CONSTRUCTION PLANS FOR WALTON OAKS

CITY OF ROCHESTER HILLS, OAKLAND COUNTY, MICHIGAN

Site Plan Review
Reviewed for compliance with City Ordinance, Building and Fire Codes
Conditions and mark-ups noted throughout plan set must be addressed prior to final approval

WALTON OAKS WATERMAIN
 WALTON BOULEVARD, CITY OF ROCHESTER HILLS
 THREE GENERATIONS ROCHESTER HILLS SITE PLANS

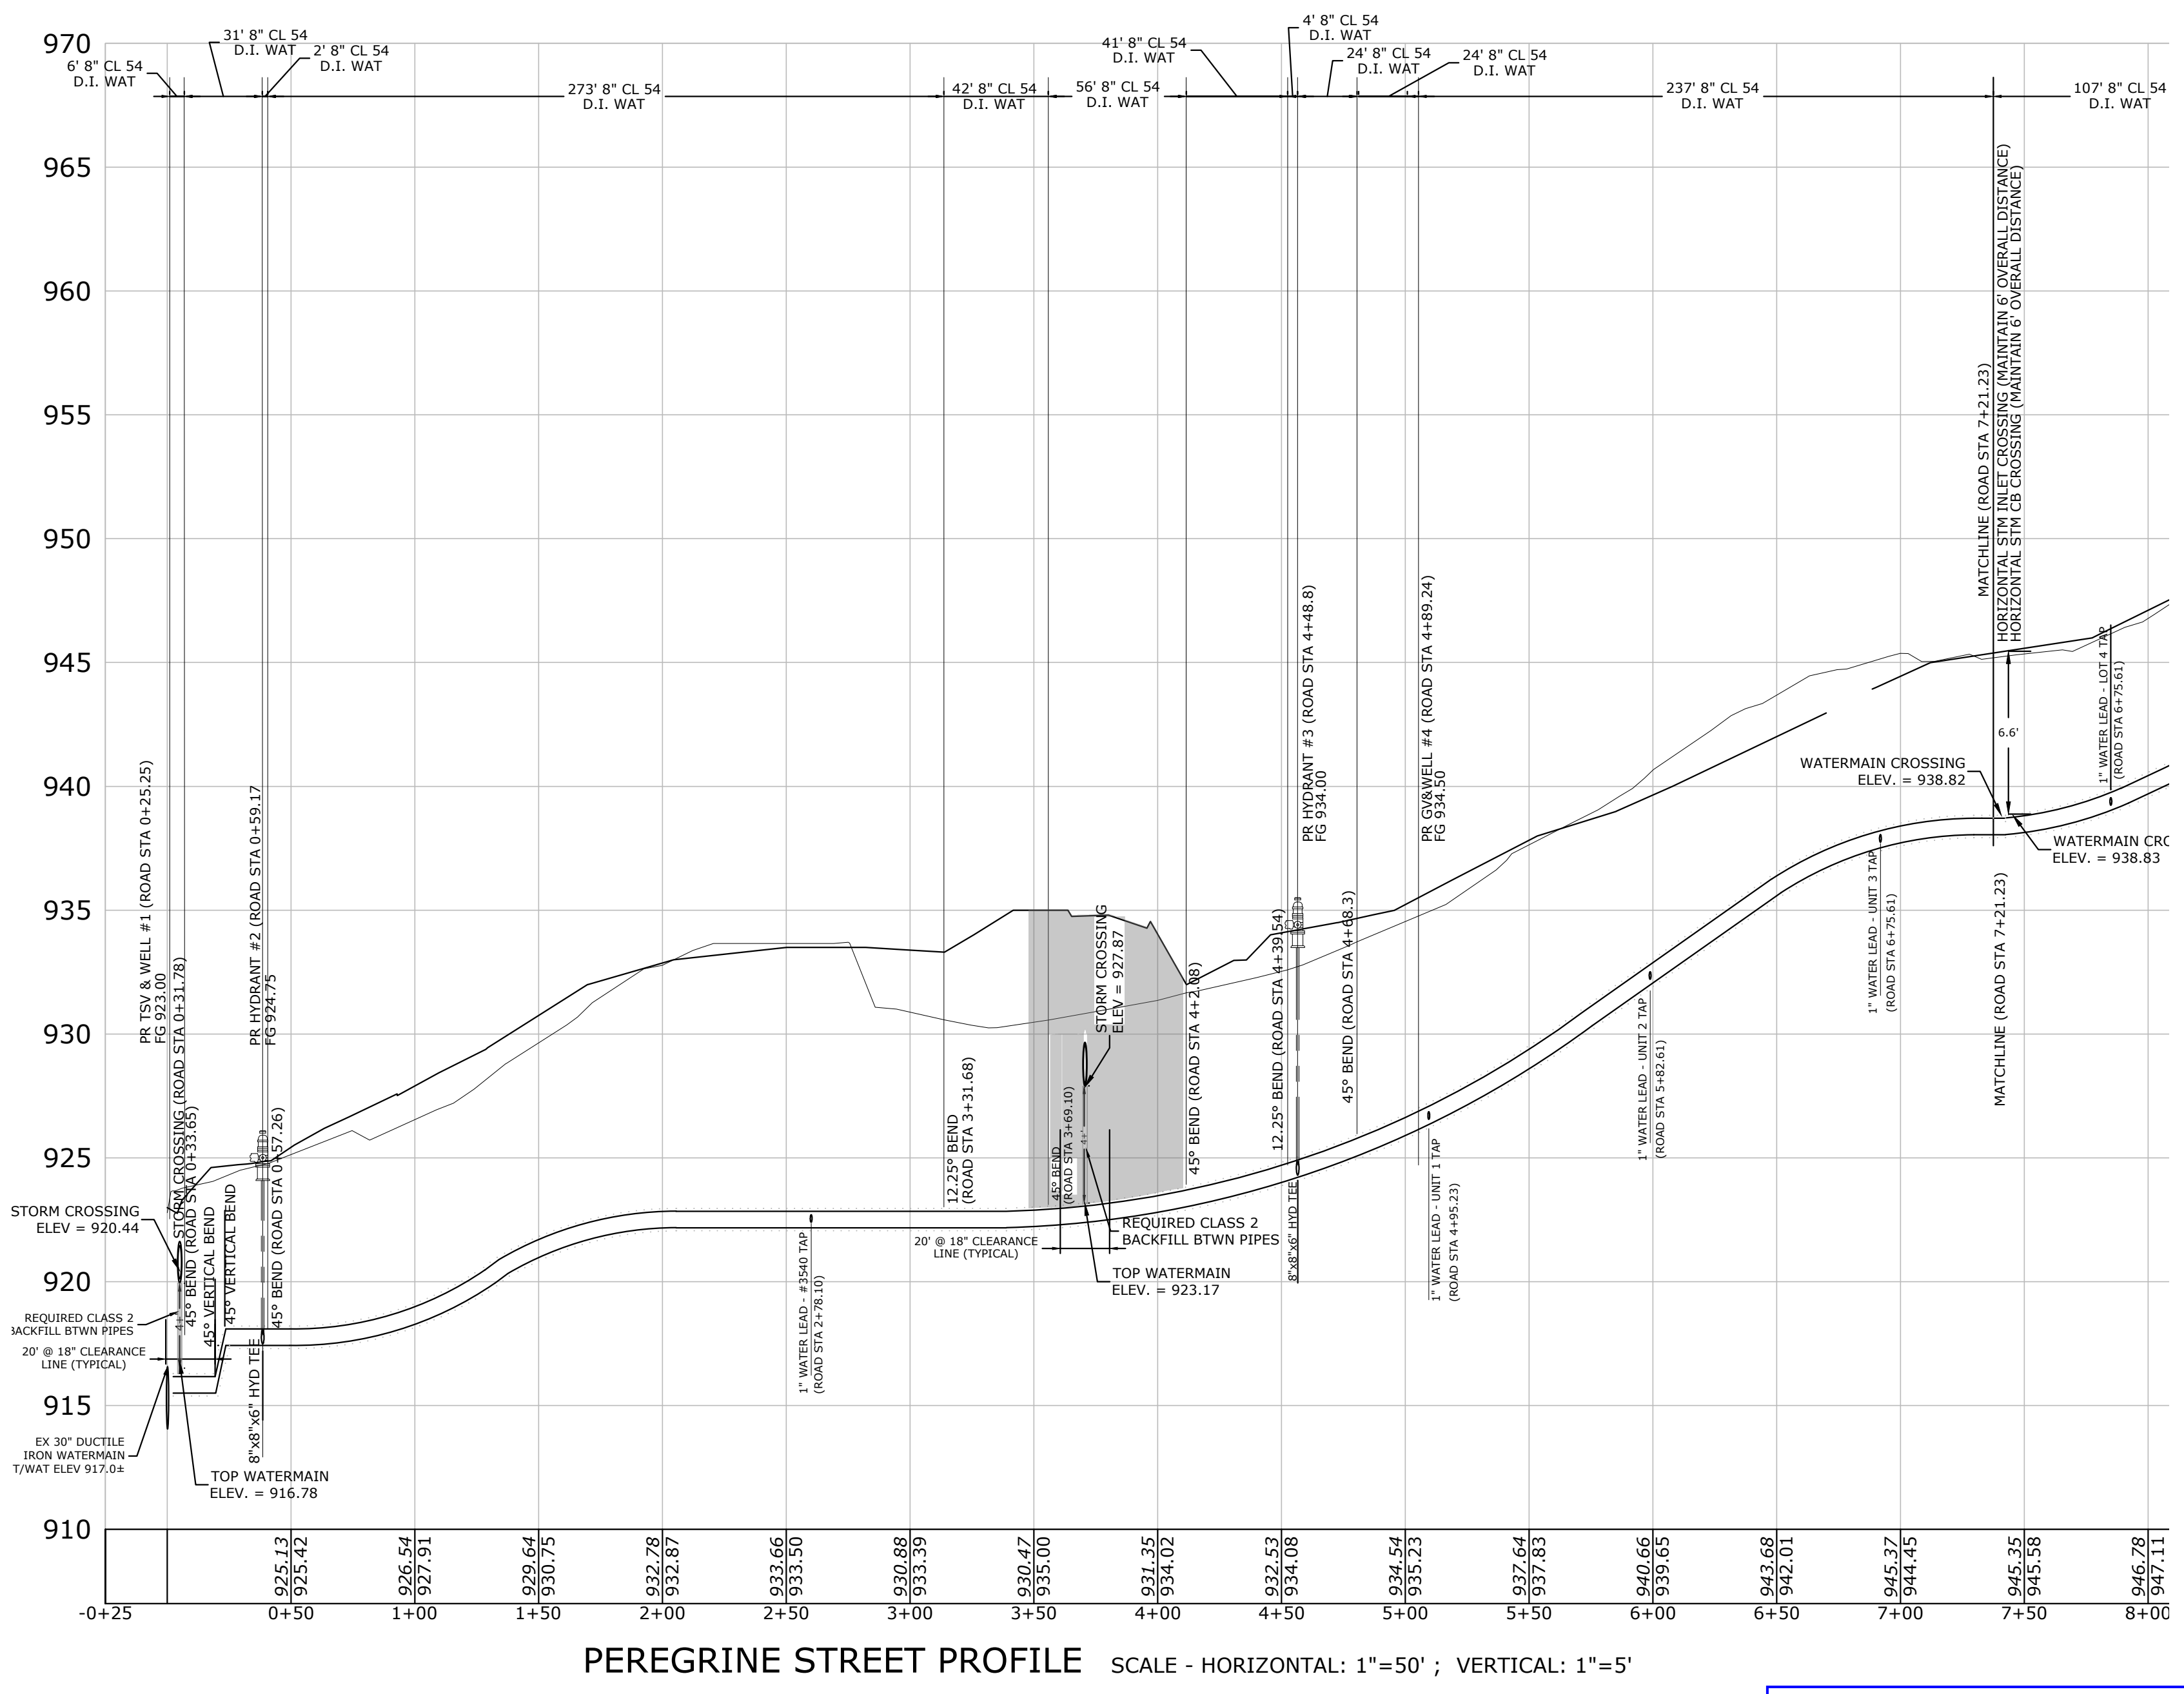
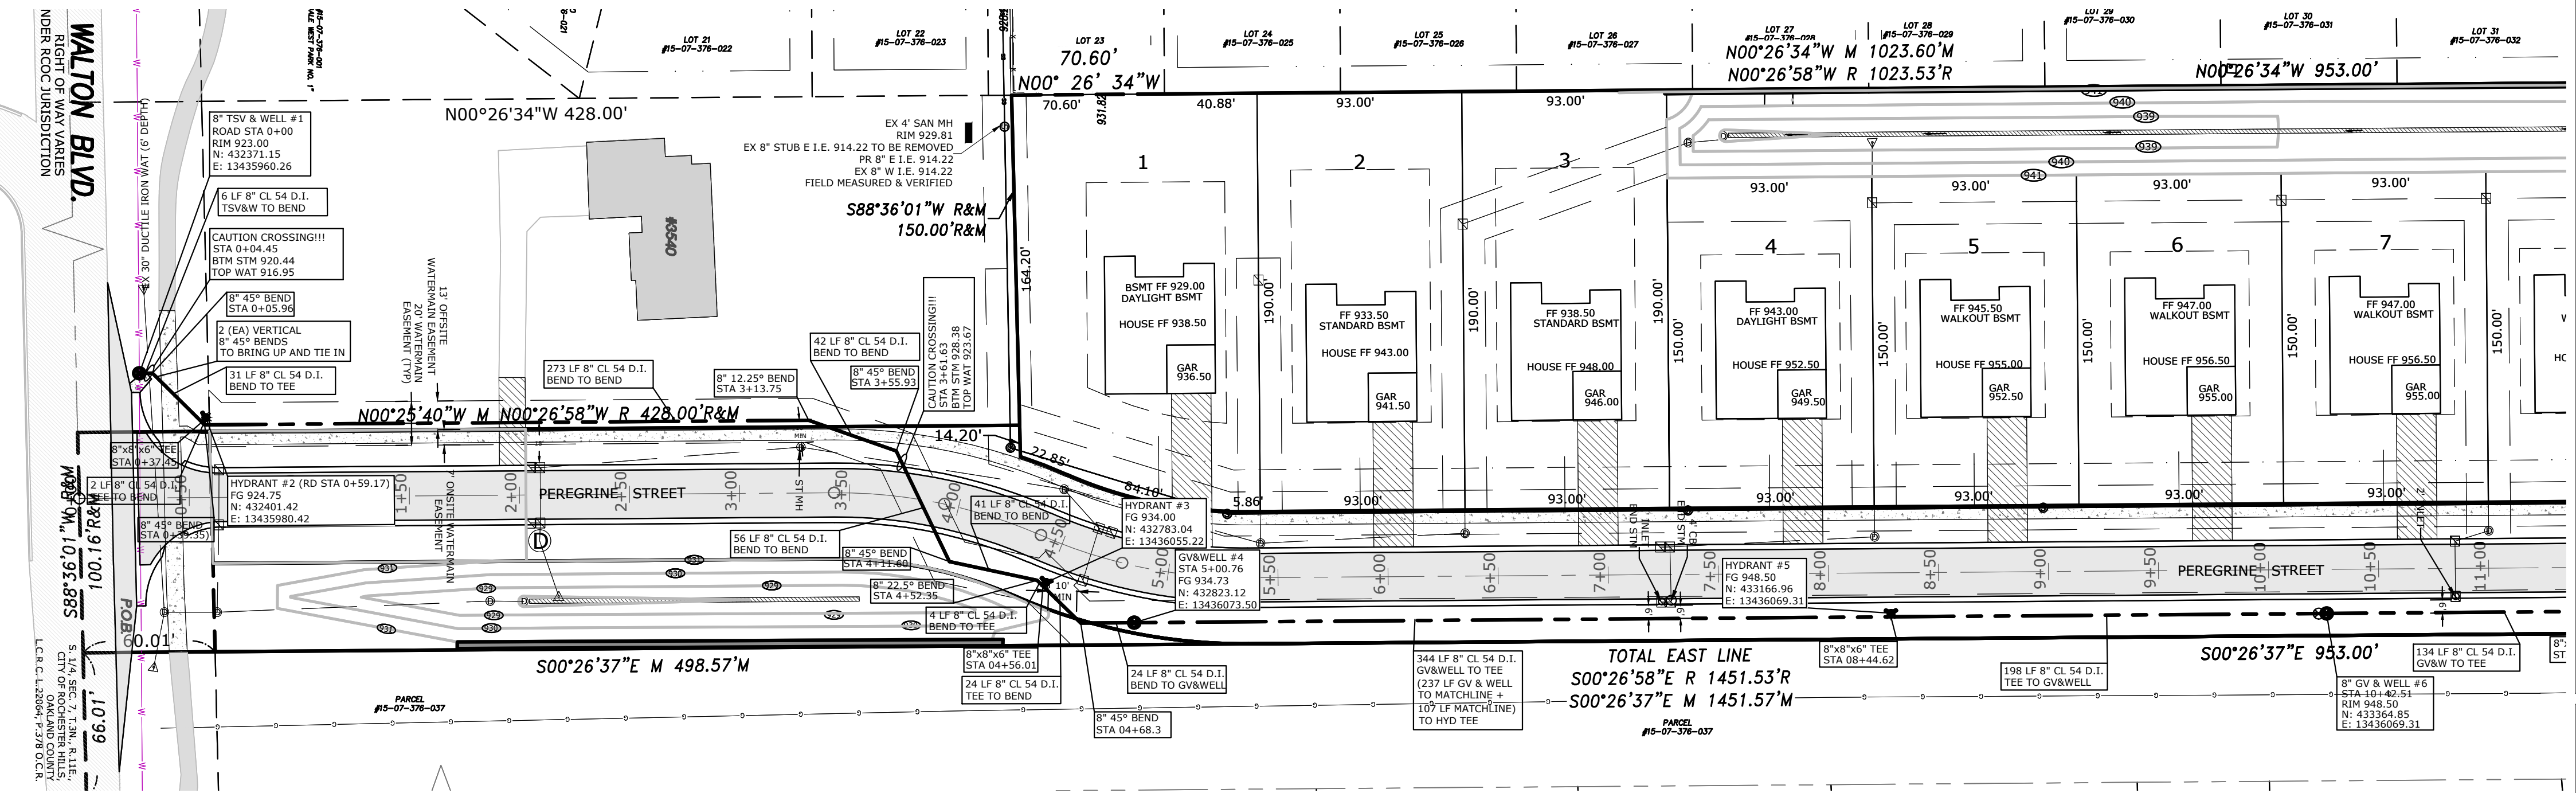
Show the proposed water leads for all units throughout the development 5 feet off the proposed sanitary sewer leads. Adjust the water main quantities to show the 1" service lines (copper or plastic) and the stop boxes to be installed as part of the initial project. Adjusted water/sewer fees will be determined after the preconstruction meeting. Provide a note on both water main sheets stating as such. This request is per the water and sewer foreman for the City of Rochester Hills.

WALTON OAKS WATERMAIN PLAN

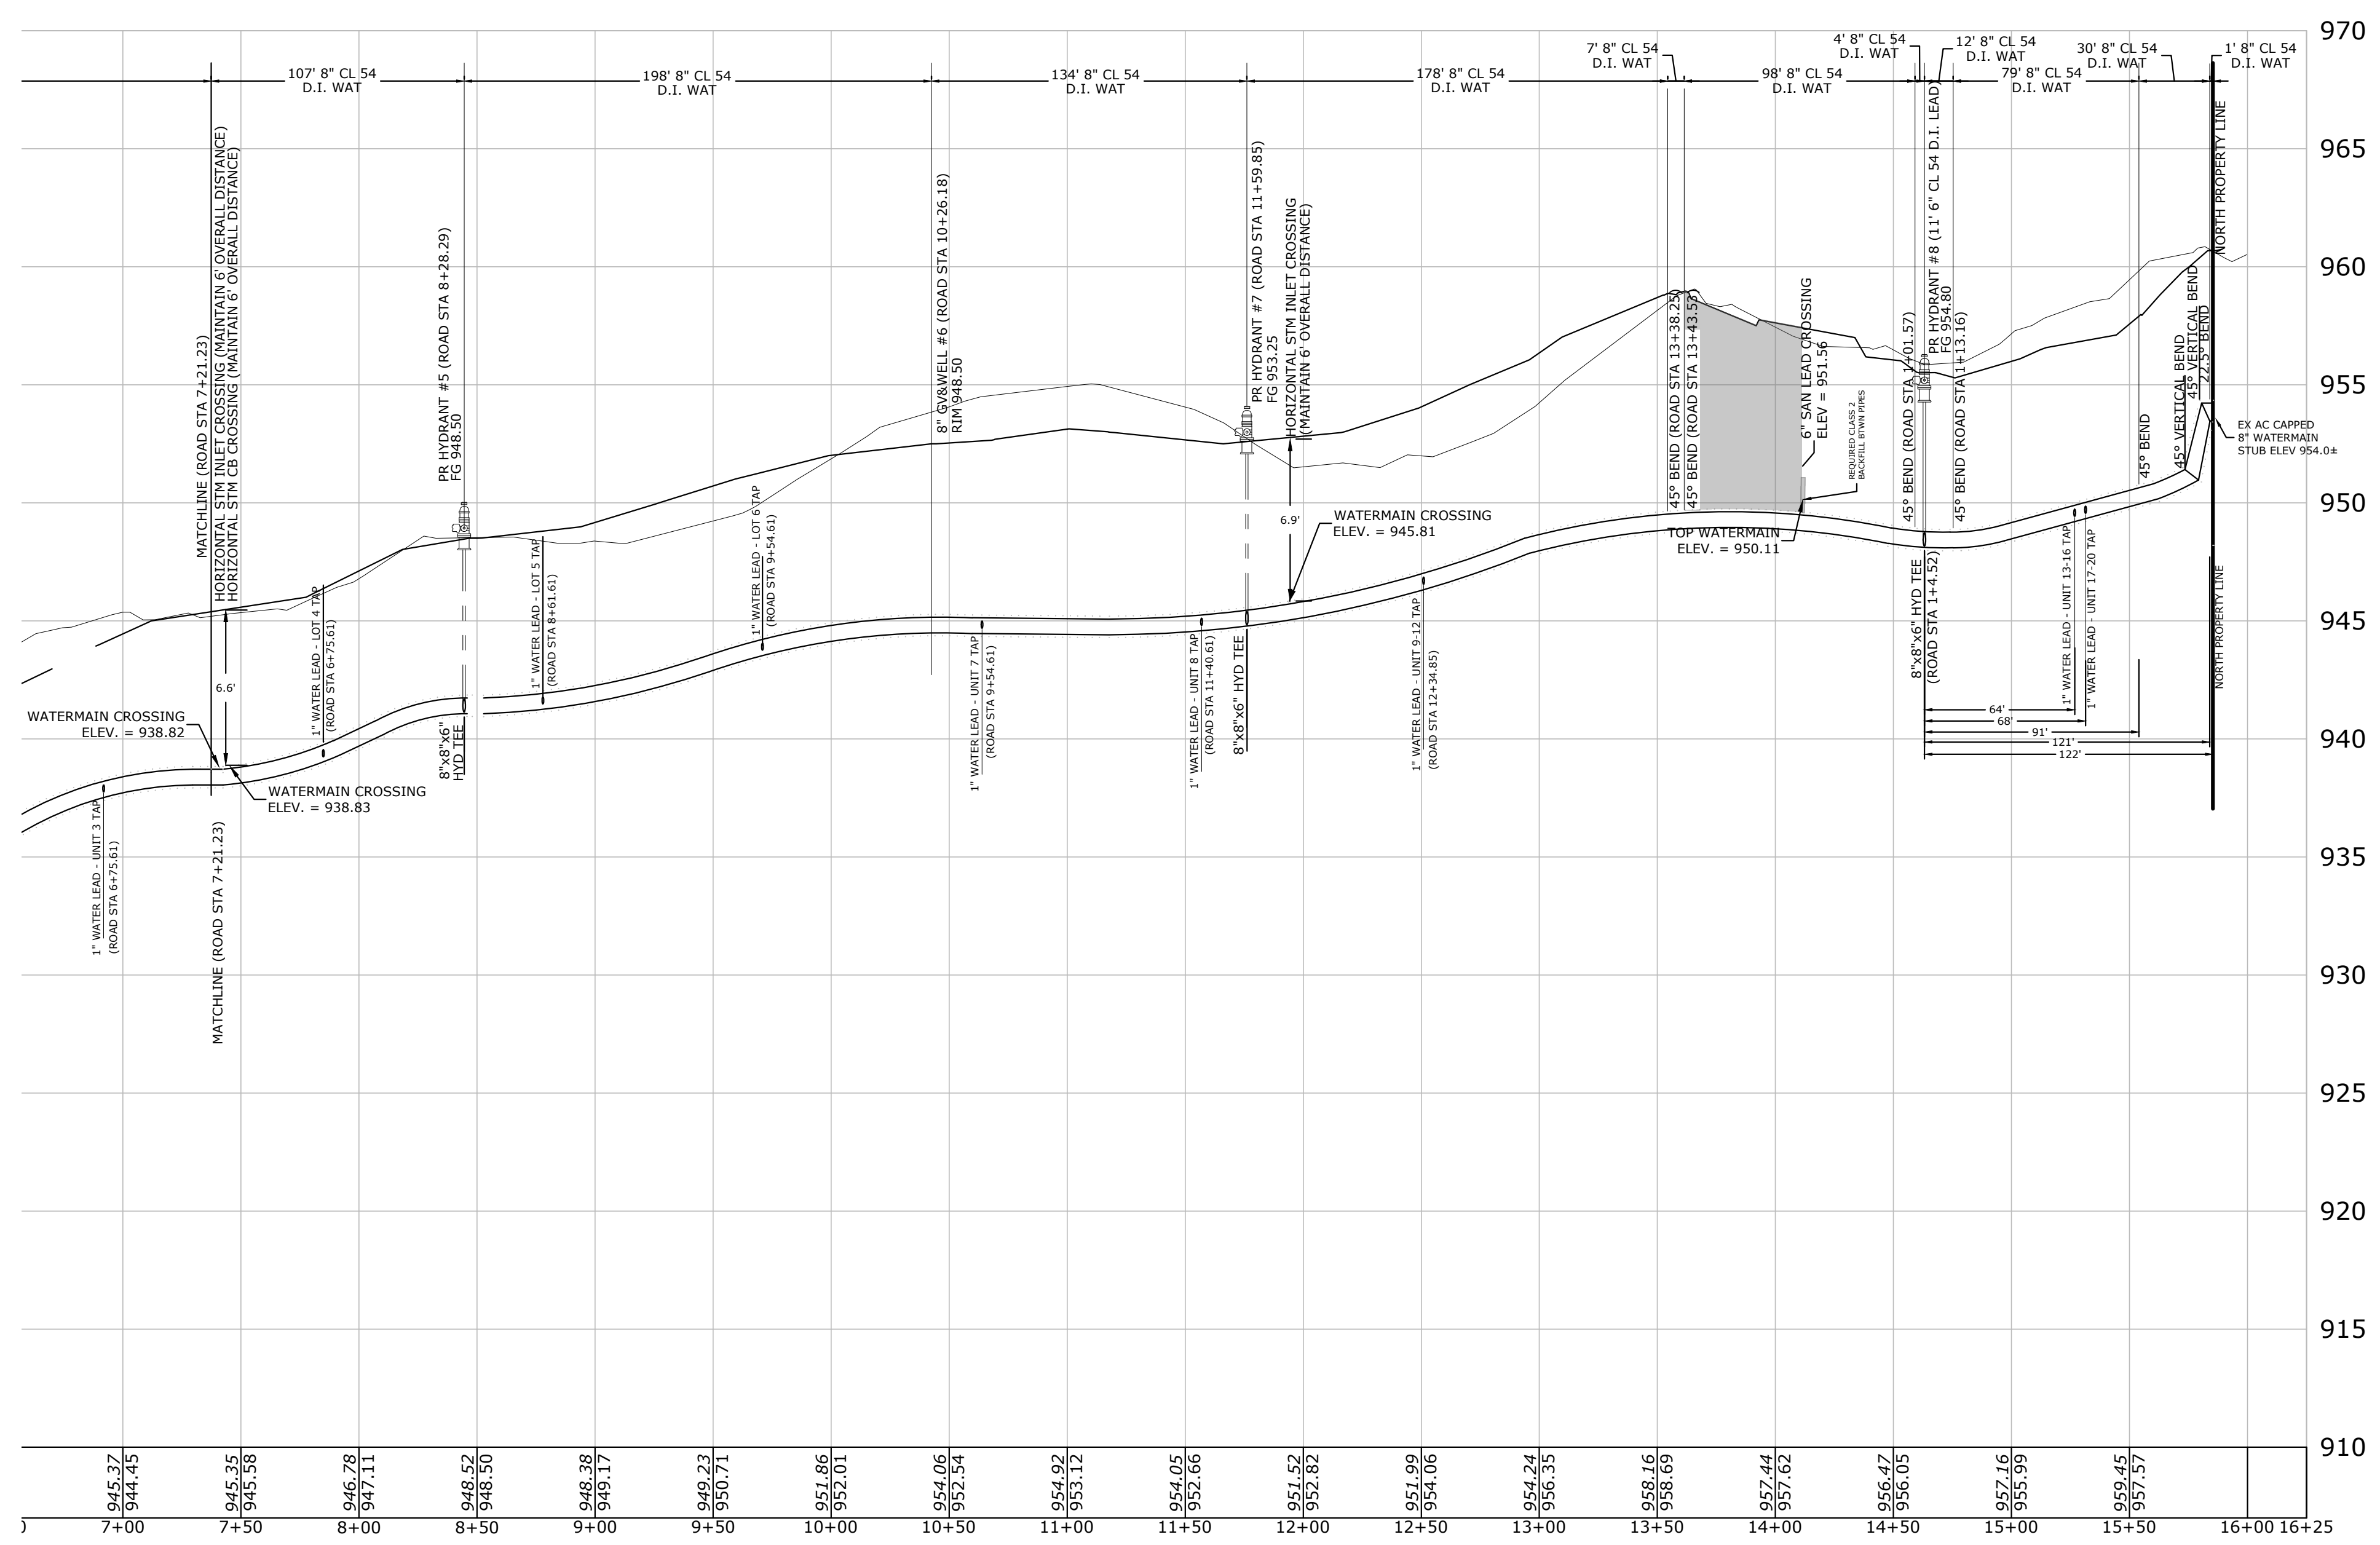
Show the proposed water leads for all units throughout the development 5 feet off the proposed sanitary sewer leads. Adjust the water main quantities to show the 1" service lines (copper or plastic) and the stop boxes to be installed as part of the initial project. Adjusted water/sewer fees will be determined after the preconstruction meeting. Provide a note on both water main sheets stating as such. This request is per the water and sewer foreman for the City of Rochester Hills.
